The Commission has issued the enclosed Amendment No. 39 to Facility Operating License No. NPF-5 for the Edwin I. Hatch Nuclear Plant, Unit No. 2. The amendment consists of changes to the Technical Specifications (TSs) in response to your requests on the subjects indicated below:

SUBJECT: EDWIN I. HATCH NUCLEAR PLANT, UNIT NO. 2

GEORGIA POWER COMPANY
OGLETHORPE POWER CORPORATION
MUNICIPAL ELECTRIC AUTHORITY OF GEORGIA
CITY OF DALTON, GEORGIA
DOCKET NO. 50-366
EDWIN I. HATCH NUCLEAR PLANT, UNIT NO. 2
AMENDMENT TO FACILITY OPERATING LICENSE

EDWIN I. HATCH NUCLEAR PLANT, UNIT NO. 2
DOCKET NO. 50-366

FIGURE 3.2.1-9

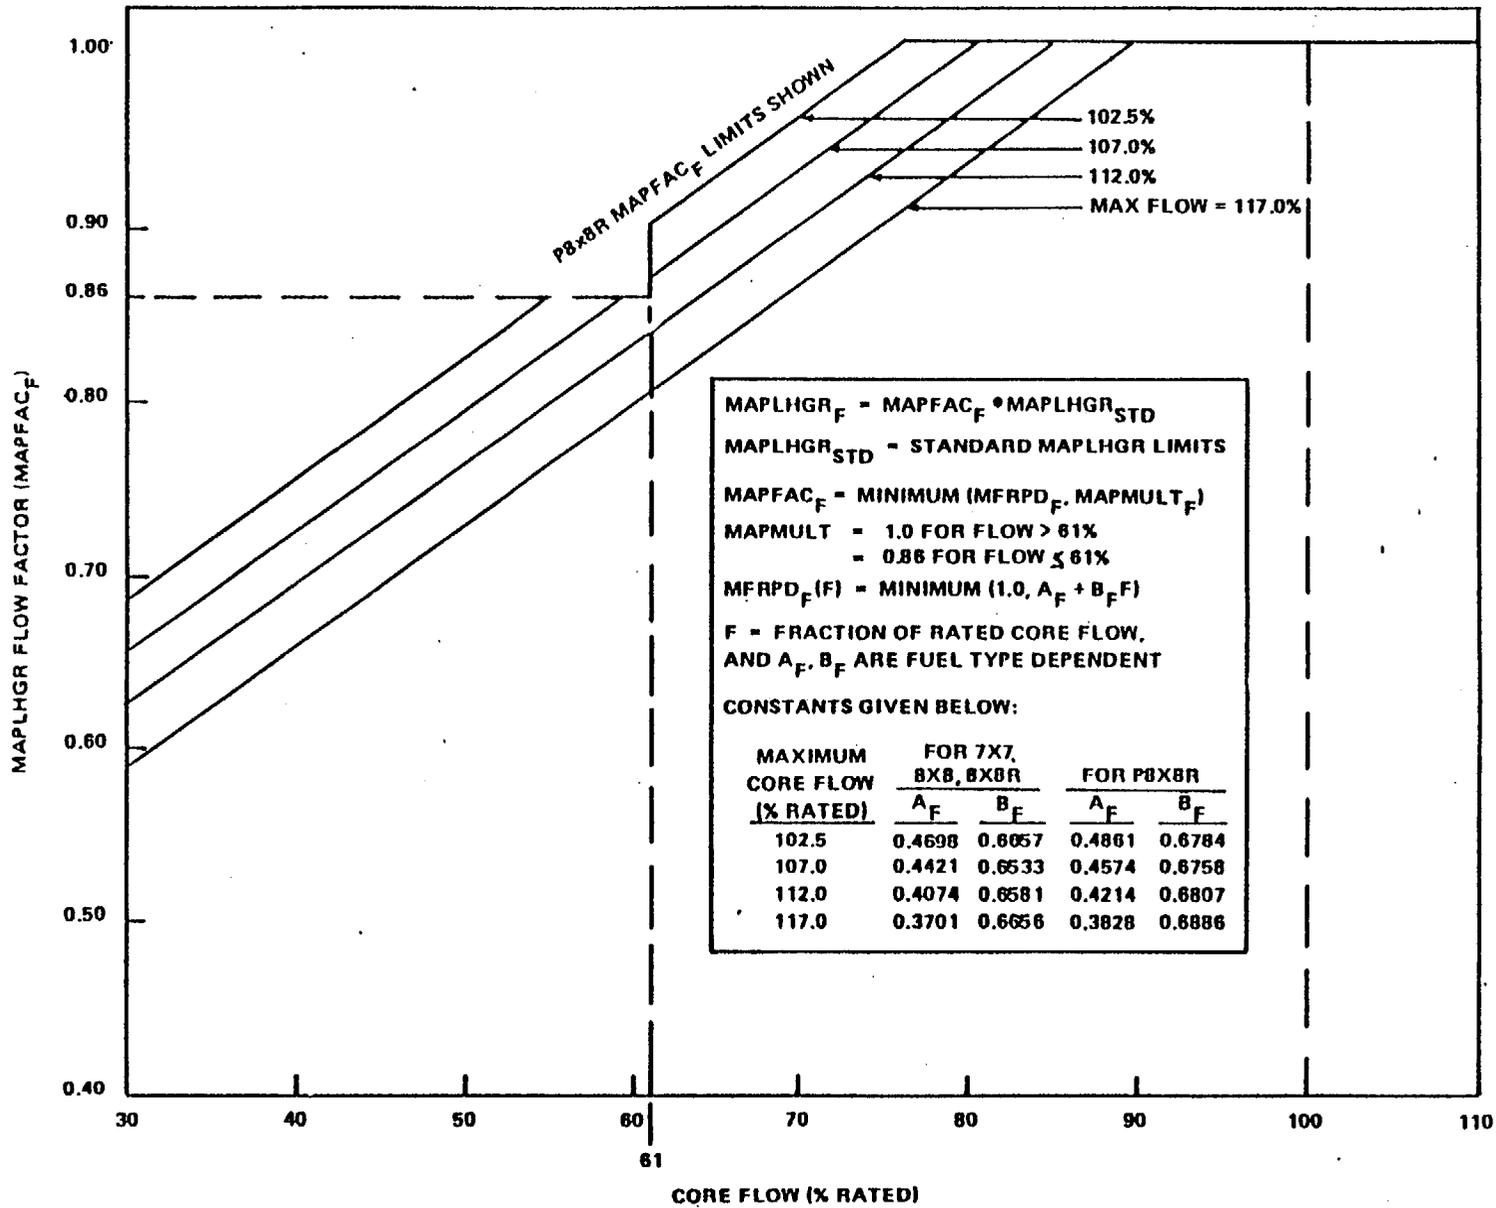
Addition of a new fuel bundle (type P8DRB284H) requires that an additional curve of MAPLHGR as a function of burnup be added to the Technical Specifications. This curve was obtained by methods described in GESTAR II (Reference 2) which have been approved for use in obtaining MAPLHGR values for extended burnup. We conclude that the MAPLHGR values for the new fuel bundle are acceptable.

FIGURE 3.2.3-3
 MCPR LIMIT FOR 7X7 FUEL
 AT RATED FLOW AND RATED POWER

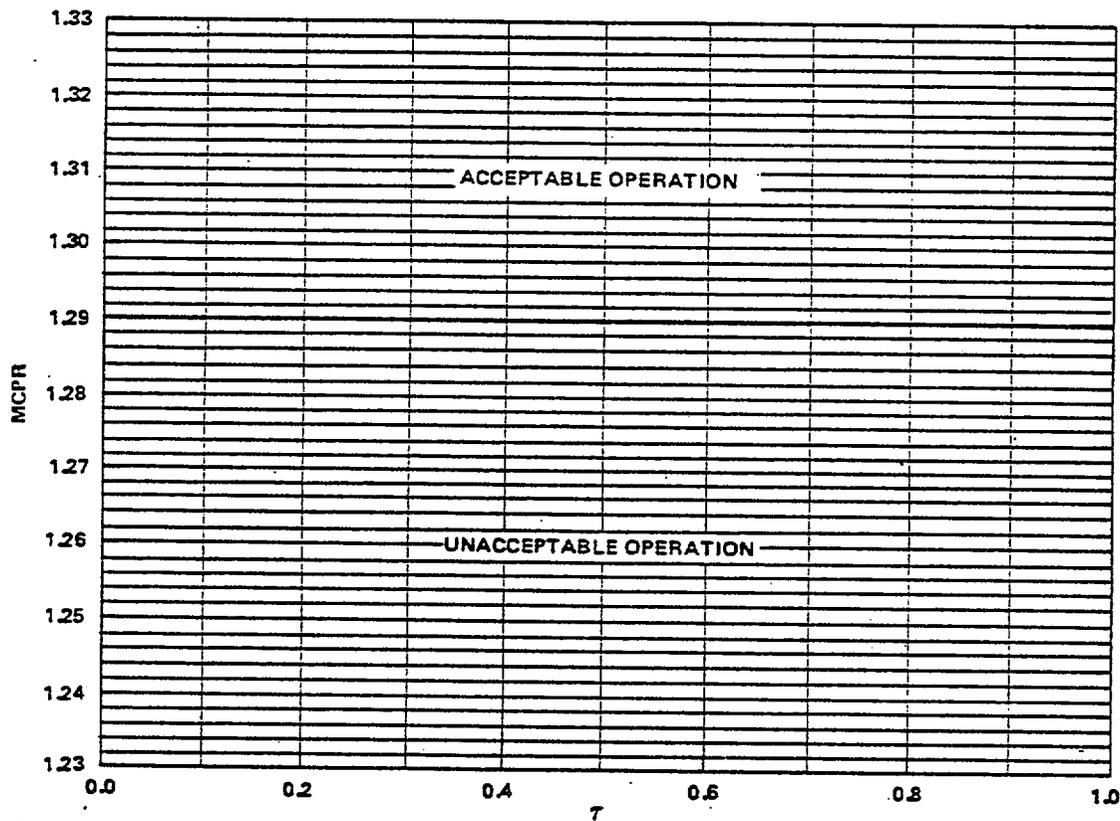
The full power, full flow OLMCPR is being revised to bound required values for Cycle 5 and beyond in order to permit licensing these cycles under 10 CFR 50.59. The proposed revisions would increase the Option B (T = 0) limits to 1.29 and the Option A limits to 1.37. The limits are currently 1.26 and 1.32, respectively, for type 8x8R fuel and 1.27 and 1.35 for P8x8R fuel. These changes are conservative and are therefore acceptable.
